RESPONSE TO REVIEW OF  
SITE PLAN CONTROL  
APPLICATION

<b>Project:</b>	New Construction	<b>Project No:</b>	2018-068
<b>Project Address:</b>	899, 901 & 903 Ages Drive, Ottawa, Ontario	<b>Date:</b>	February 28, 2019
<b>Attention:</b>	Melanie.Gervais@Ottawa.ca		
<b>Application No:</b>	D07-12-18-0182

899 Ages Drive, Ottawa, ON  
Exterior Lighting Cut Off

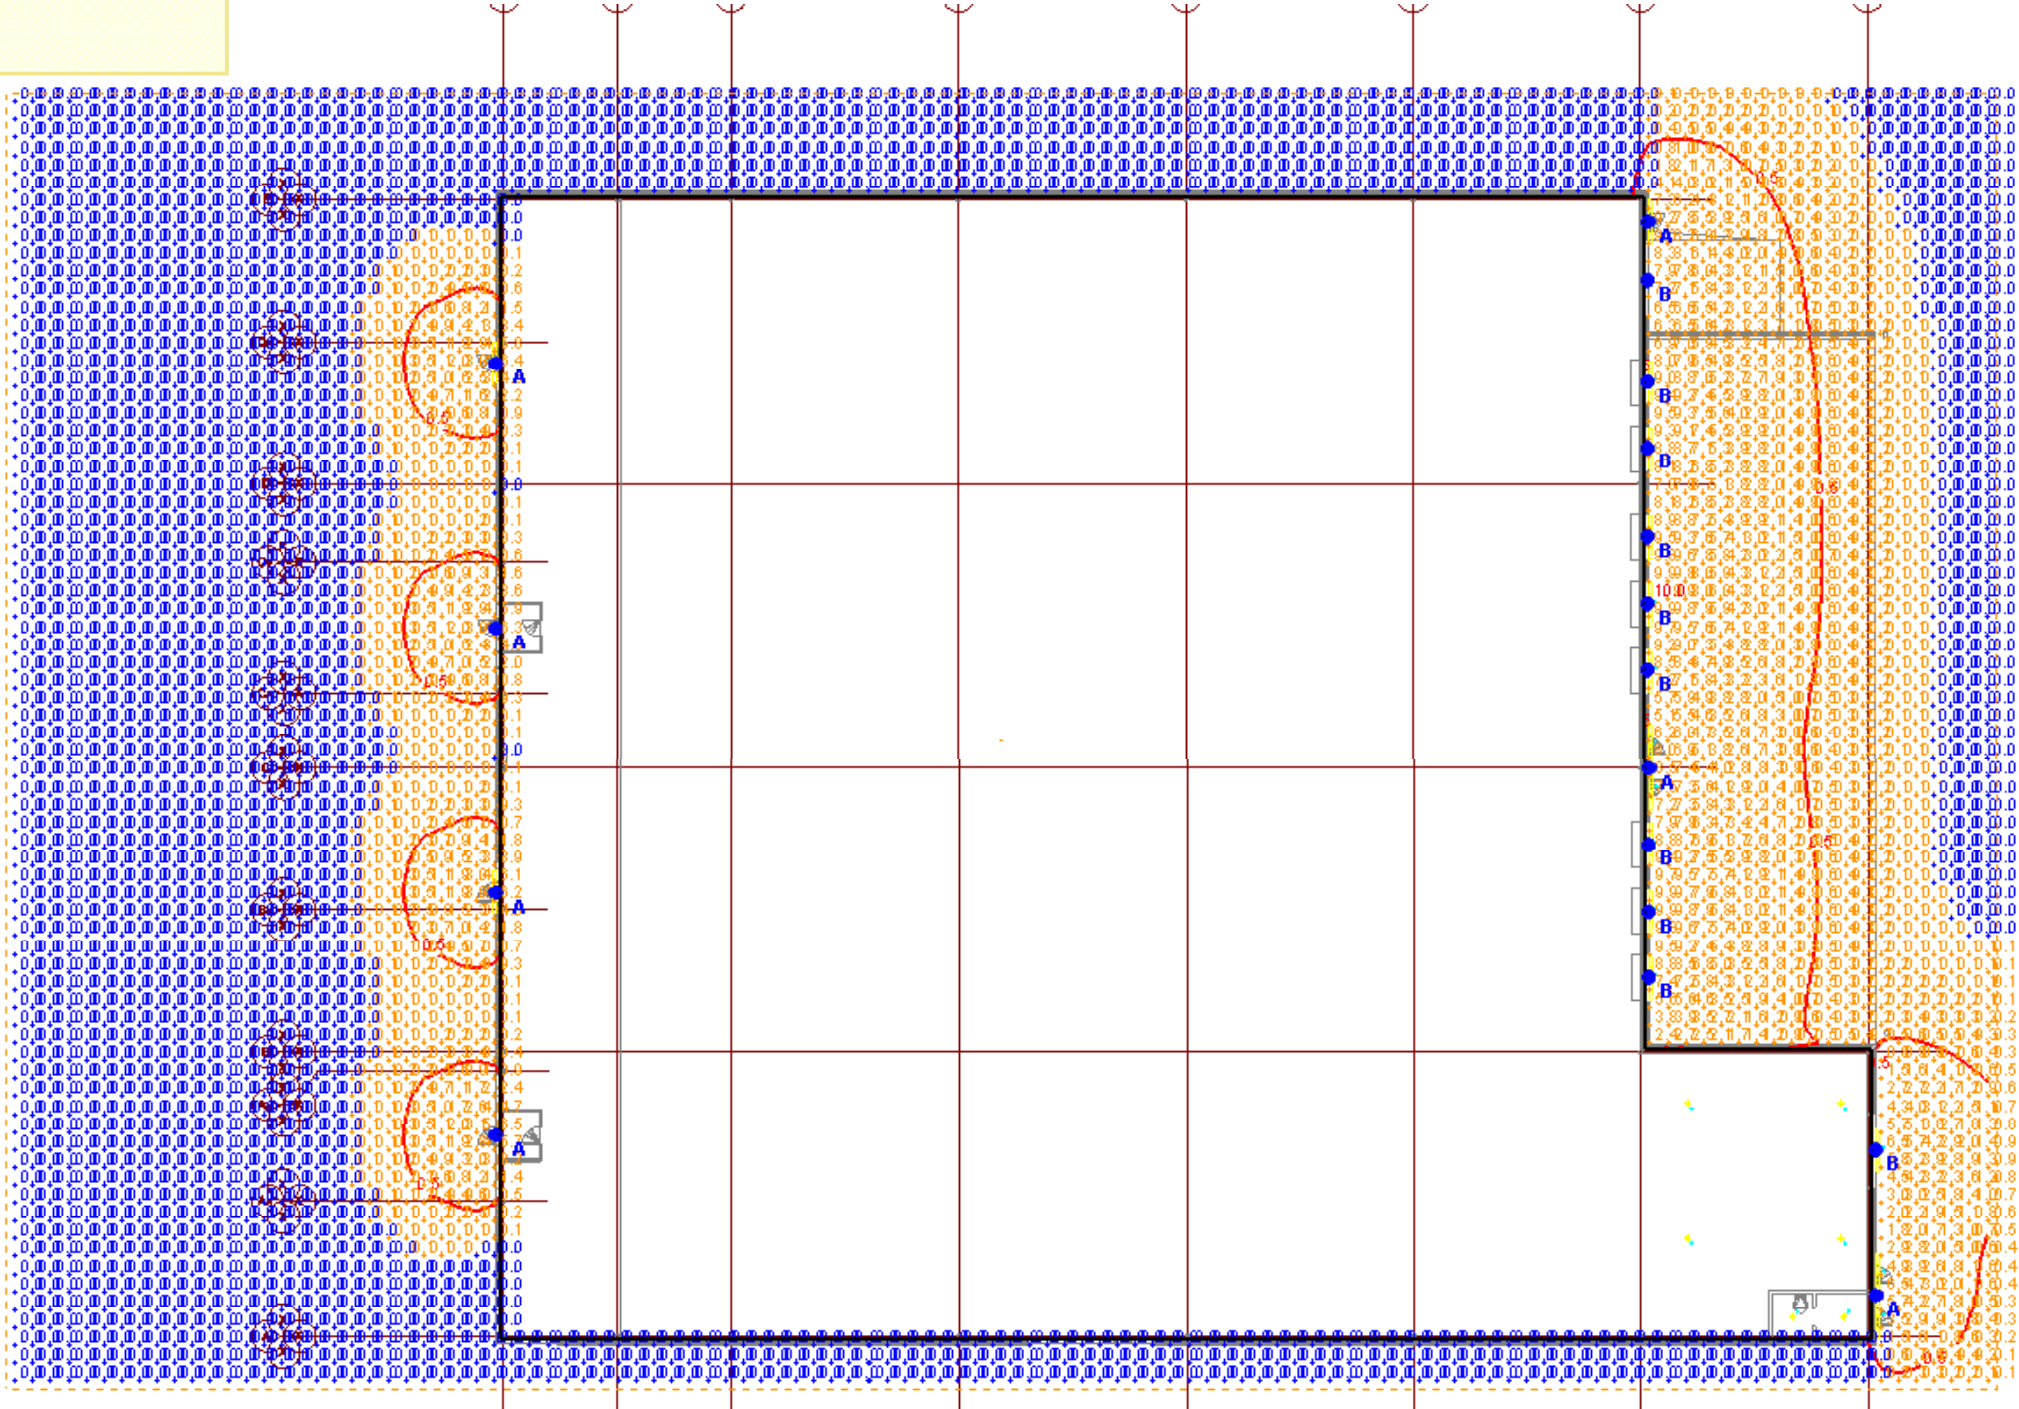
Item 7: Reference Electrical Engineering drawings E1 to E5 for 899 Ages Drive & 903 Ages Drive. The design was performed by a professional engineer licensed in Ontario and has been designed using only fixtures that meet the criteria for full cut-off classification, as recognized by the Illuminating Engineering Society of North America. Additionally, the lighting level has been modeled to ensure cut-off levels meet the required levels, reference attached.
